Planning Department Brennon Williams, Director

RE: Lot 6 Block 6 Volcano Cliffs Unit 18 SAD 228 6608 Kimmick Dr. NW **Grading and Drainage Plan Engineers Stamp Date 4/26/2021 (D10D003M6)** Pad Certification Date 6/10/2021

DRAINAGE AND TRANSPORTATION INFORMATION SHEET (REV 6/2018)

C1

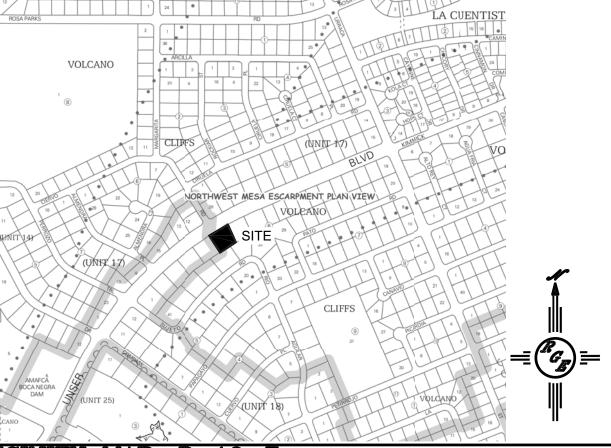
Based upon the information provided in your submittal received 6/11/2021, this plan is approved PO Box 1293

for Building Permit.

Reiterate to the Owner/Contractor that a separate permit for a garden/retaining wall must be obtained, with the approved G&D plan and Pad Certification. Also, let the owner/contractor know that if a pool is to be added in the future the G&D plan will need to

be modified showing the location of the pool and the land treatment differences.
